## MATTER 9: SPATIAL STRATEGY, GREEN BELT AND COUNTRYSIDE PROTECTION

Guildford Local Plan Examination  
Representor: Save Hog's Back

## MATTER 11: SITE ALLOCATIONS – A26 BLACKWELL FARM

**New road layout proposals at Blackwell Farm  
by the University of Surrey  
August 2017**

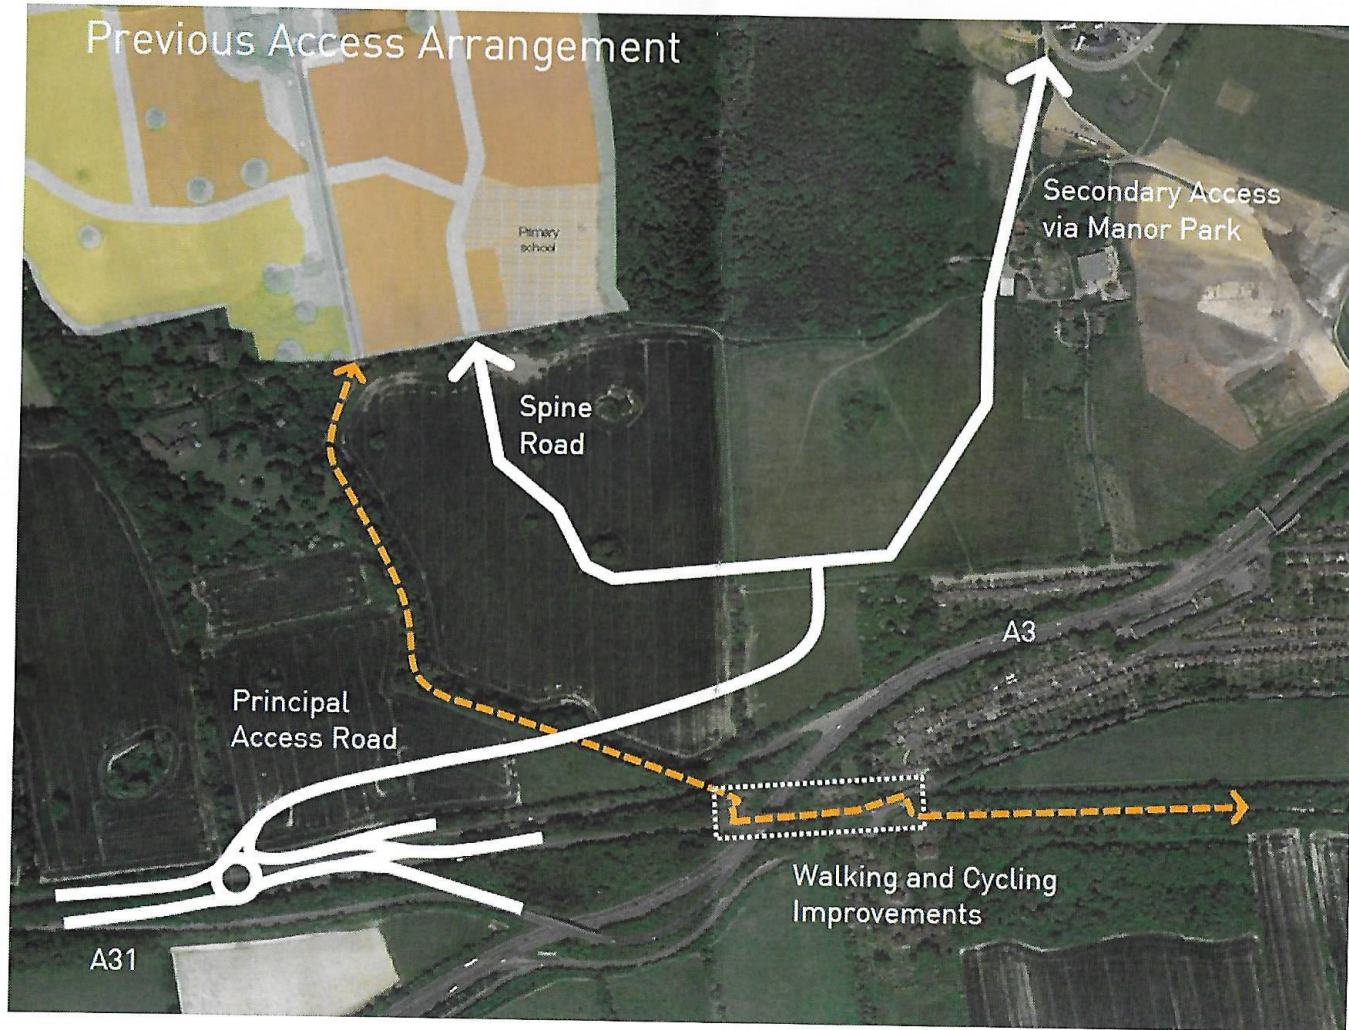
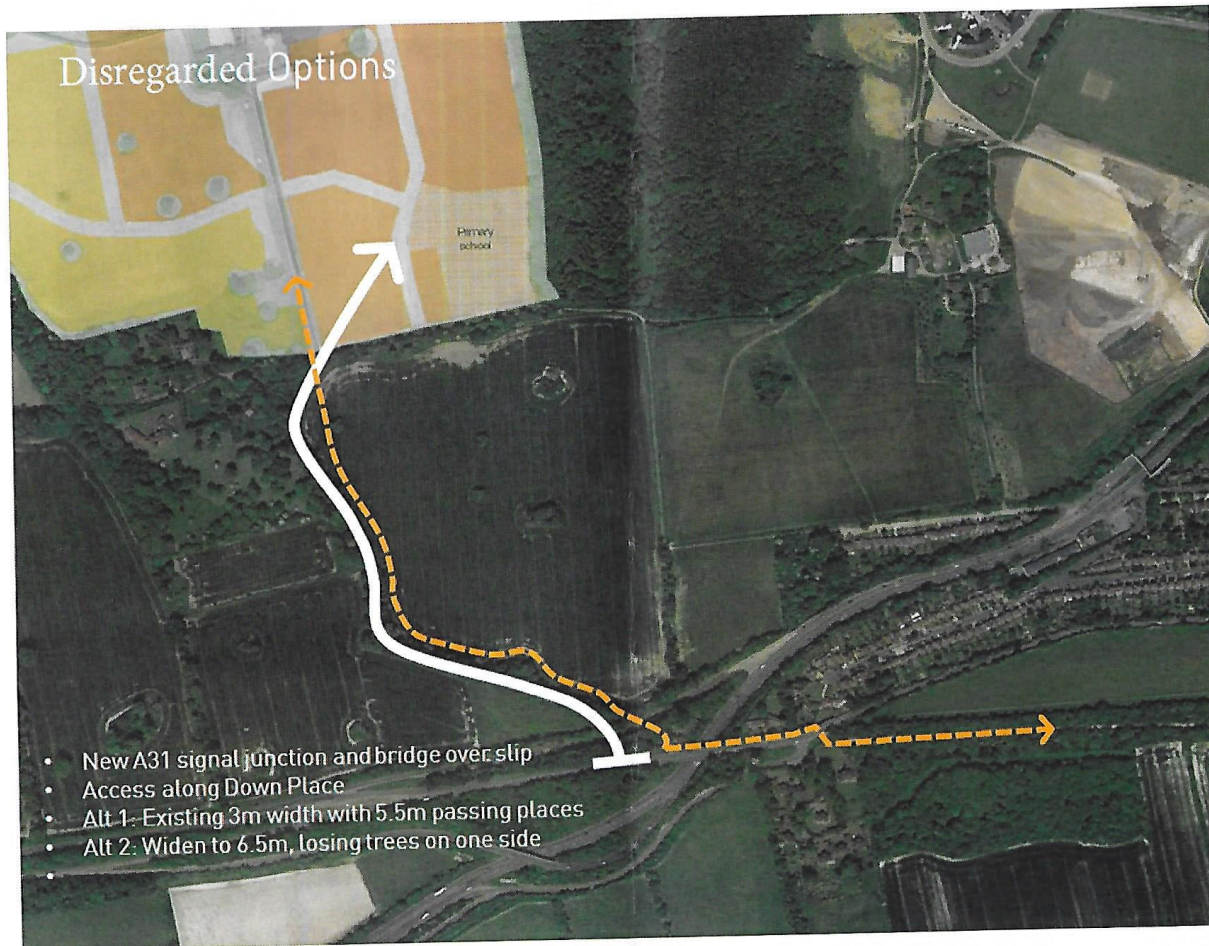
13. The Submission Plan has proposed a narrow corridor for the link road up the north slope of the Hog's Back. This is within the Surrey Hills Area of Outstanding Beauty, and the Hog's Back is one of the most iconic landscape features of all AONBs and world famous. The Council's response to the Inspector's Initial Q8 states *"it is proposed to use the existing access road, Down Place, located in land parcel H1. The road is however currently narrow and would therefore require upgrading. This could result in a new road parallel to the existing on the up-hill side of the road"* (paragraph 8.70).

14. The notion of widening the existing Down Place is frankly absurd, as this would take out the wonderful mature trees on one or both sides of the lane, damaging the landscape and reducing any screening benefit otherwise on offer. We have therefore assumed that the University of Surrey's 'Feasible Option', with a new road on higher ground to the south of Down Place, is the working proposition. This was provided informally to local residents in August 2017 as part of a package of new road layout proposals, and is attached as Appendix 1. Like the Submission Plan, this assumes a sharp bend at the foot of the slope, breaking through Down Place. Artington, Compton, Wanborough and Worplesdon Parish Councils commissioned an independent landscape and visual appraisal of this access road. Issued by Land Management Services in January 2018, the study concludes that:

15. We consider the Feasible Option unacceptable in landscape terms, accompanied by noise, pollution and the eye-catching effect of moving vehicles. Blackwell Farm is the only major housing development directly impacting the AONB. 'Exceptional circumstances' for it in terms of NPPF paragraph 116 (for major development) have not been demonstrated. They have not even been claimed by the Council. Given that a major urban development of 1,100 hundred homes at Flexford and Normandy, outside the AONB, was removed by the Council after being proposed at Regulation 19 stage in June 2016, the Council cannot claim that alternatives less damaging to the AONB do not exist.

(i) The maximum desirable gradient for the road according to the Design Manual for Roads and Bridges is 6.0%. The existing gradient approaching the A31 is 6.5%. Traffic queuing to the traffic lights on the A31 junction would be on a steep uphill gradient which is a hazard that would be very difficult to avoid (the *Strategic Highway Assessment Report*, June 2016, Table 4.11 forecast a 35 second delay on this junction, meaning distinct tailbacks on the hill). The Highways Authority would insist on efforts to reduce the gradient of the road which have not been recognised in the Submission Plan. A shallower gradient would spread the road much further across the north flank of the Hog's Back and would be still less screened by the Down Place trees. There may still be a need for a crawler lane, with added landscape impact.

(ii) Significant earthworks would be needed to accommodate a wide road passing at an angle down a steep slope. This would cut into the chalk (inevitably resulting in a scar visible for miles) and building up the downslope side of the road. These would have a significant landscape impact in this protected area.

(iii) The sharp road bend towards the bottom of the slope, similar to that on the existing Down Place, would be wholly unacceptable in highways terms for an access road to a major urban extension. The University has already introduced a 10mph speed limit on Down Place due to the 'hazard' of this bend. As proposed the new road would be a significant hazard for motorists. Overcoming this would take the road through a wider sweep, greatly increasing landscape damage.

17. The link road cannot be built as indicated in the Submission Plan. Land Management Services comment "*A significantly larger land take than that shown on the feasible option would be required in order to create a safe and viable highway. It is anticipated that extensive cut and fill works would be required to create suitable gradients. The land take and consequent impact on landscape character and visual amenity would, therefore, be substantially greater than suggested by the feasible option alignment*". Taken together we reject the vague claim by the Council in response to the Inspector's Initial Q8 that "*Whilst it does also run through both AONB and AGLV, the impact that the upgrading would have on the landscape can be mitigated through the retention and enhancement of the tree cover already present along its length*" (paragraph 8.70). There is no policy presumption that a local major development (a road) should override the national interest in protecting AONB.

## Initial Junction Arrangement

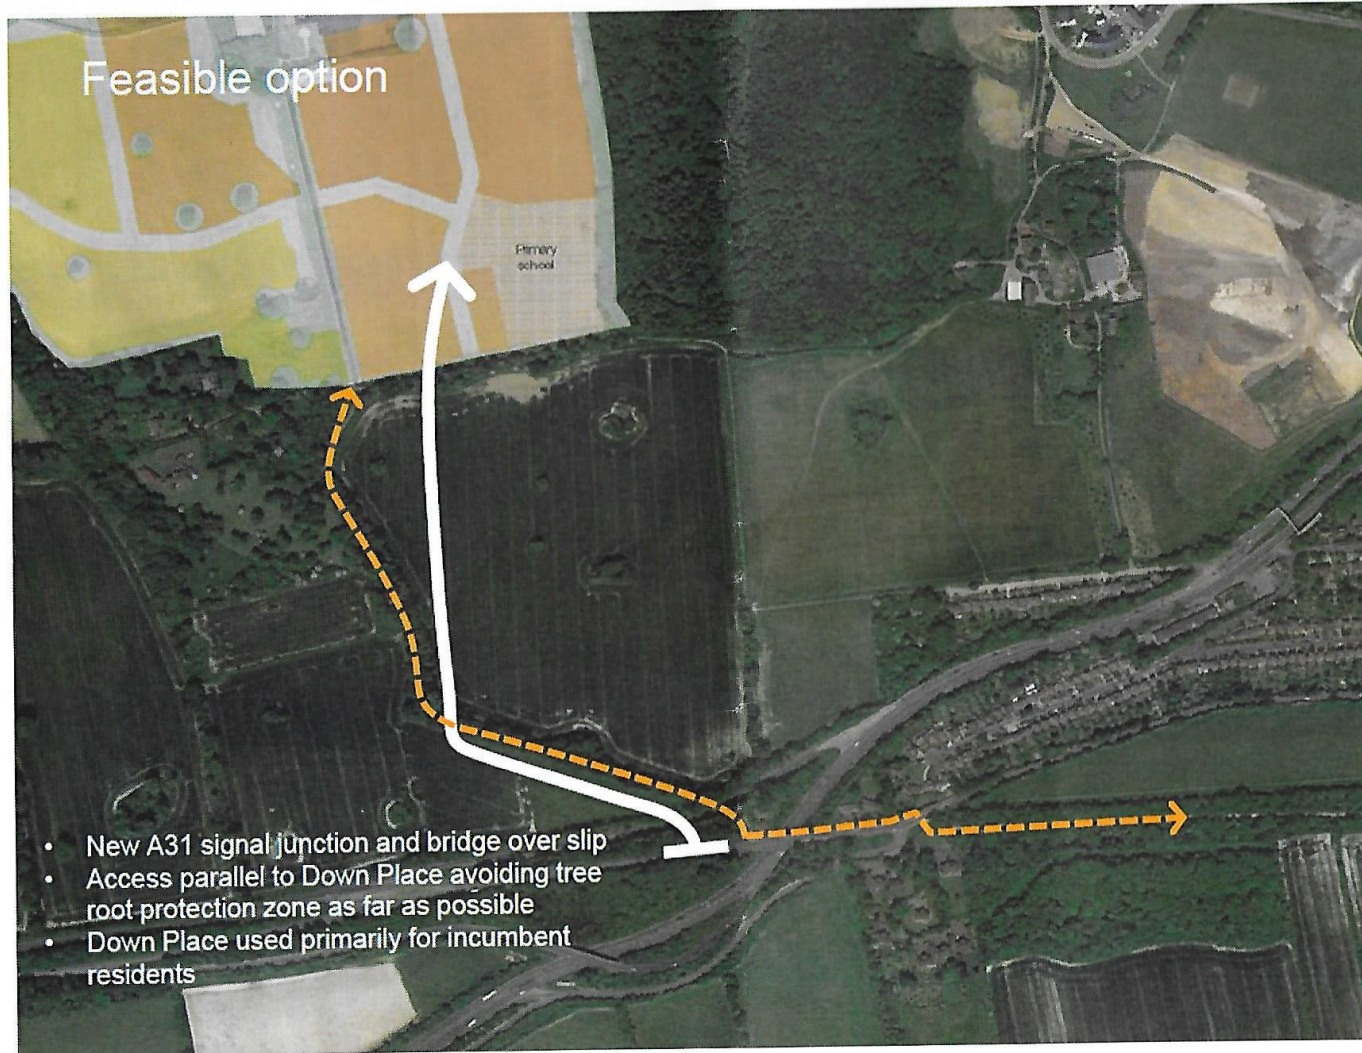
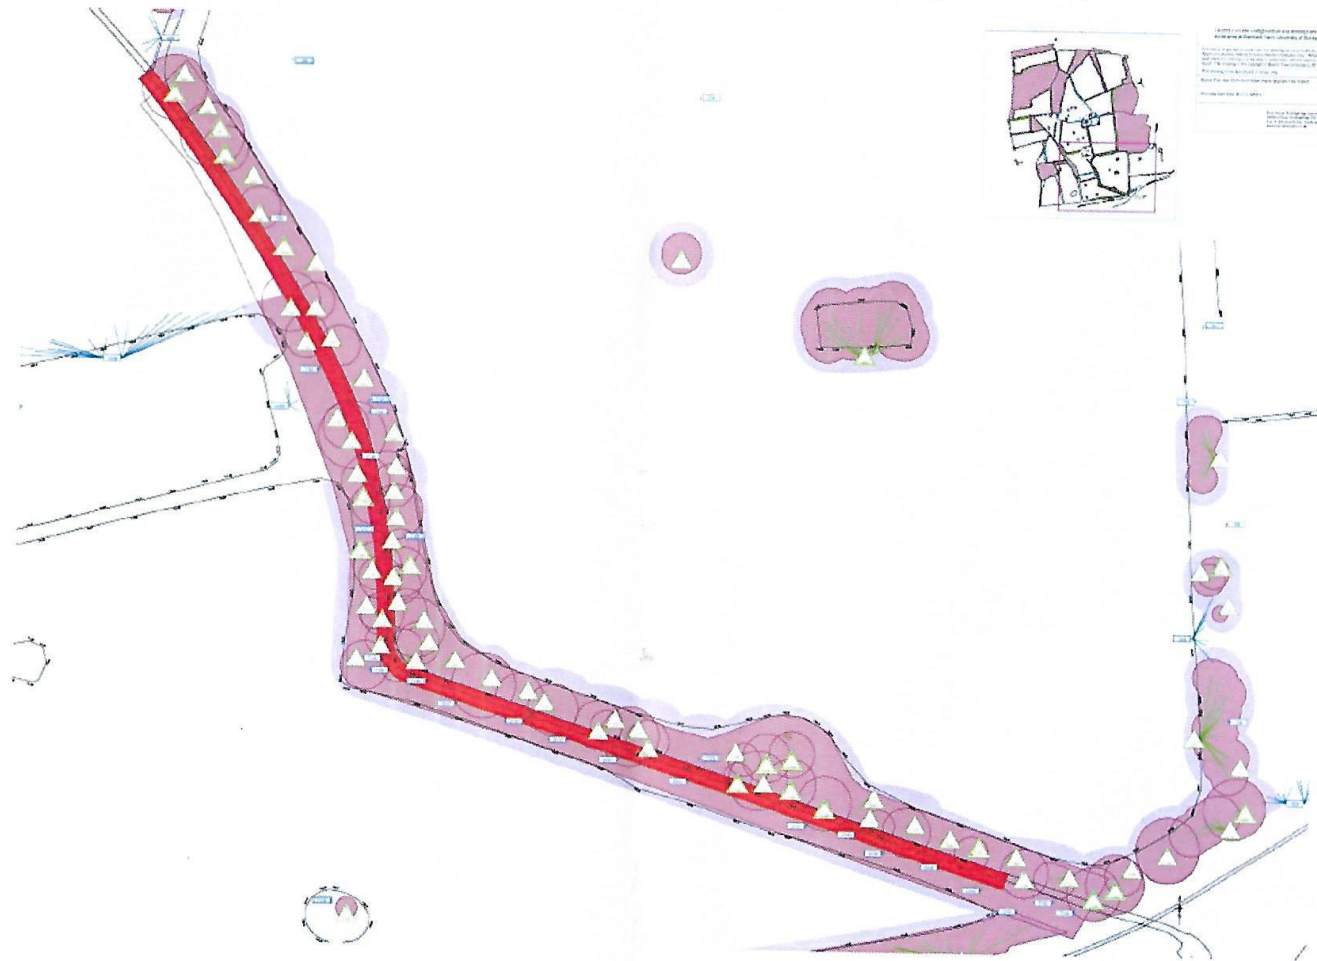
18. An 'Initial Junction Arrangement' issued by the University of Surrey (Appendix 1) shows that the existing Down Place bridge and access will not be widened. Instead a new junction with the A31 would include a new bridge over the slip-road onto the A3 (precluding drivers joining the A3 northbound). Infrastructure Project LRN3 identifies the cost of the junction as "*£5m developer funded*". Our independent transport consultant advises that the cost of the junction and bridge would exceed £10m. The junction could physically be achieved but not for the stated cost.

19. The Submission Plan states that the junction "*will be signalised*" (Policy A26 Infrastructure Requirement 1). The Council has not carried out the assessment work and design layouts to demonstrate that a signalised junction could deal with the volume of traffic the Council expects to use it. There are two major problems:

(i) Traffic from Blackwell Farm exiting this junction is estimated by Surrey CC to be 415 vehicles per hour over the AM peak three hours. Much of this traffic will wish to turn left for Guildford and the north. However, the bumper to bumper congestion on the A31 at this point during the morning peak, not taken into account in the model, will preclude a rapid rate of traffic egress in that direction. A queue will build up on the steep north side of the Hog's Back and the delay be substantially greater than 35 seconds (paragraph 10(i) above).

(ii) Our transport consultant has carried out a preliminary assessment of the junction (in Appendix 3 submitted with our response to the June 2016 Regulation 19 consultation). This shows that, based on the Design Manual for Roads and Bridges TD42/95, Figure 2.2, a roundabout should clearly be preferred. This in itself would have major implications for construction due to topography, changes of level and confined space. Those in turn would have landscape and other consequences. A signalised junction would be lit, the Highways Authority advises, having adverse consequences on the currently dark AONB at night, and a roundabout would intensify this problem. Councillors have previously consistently opposed a roundabout on the top of the Hog's Back for landscape reasons (e.g. at the Council
